Appl. No. 10/604,569 Amdt. Dated 10/27/2004 Reply to Office Action of Oct. 01, 2004

REMARKS/ARGUMENTS

Figure 1

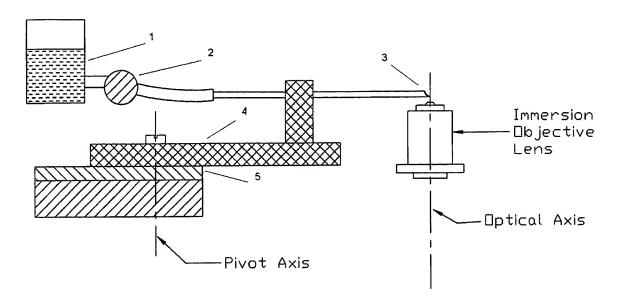
It has been correctly stated (Claim Rejection – 35 U.S.C 112) that claims 3-4 were rejected for failure to comply with the written description requirement. This error has been rectified by a slight embellishment of the Figure 1 drawing and associated text revisions.

The drawing has been revised and forms a part of this correspondence to show the presence of a coaxial vacuum extraction channel in the dispensing arm.
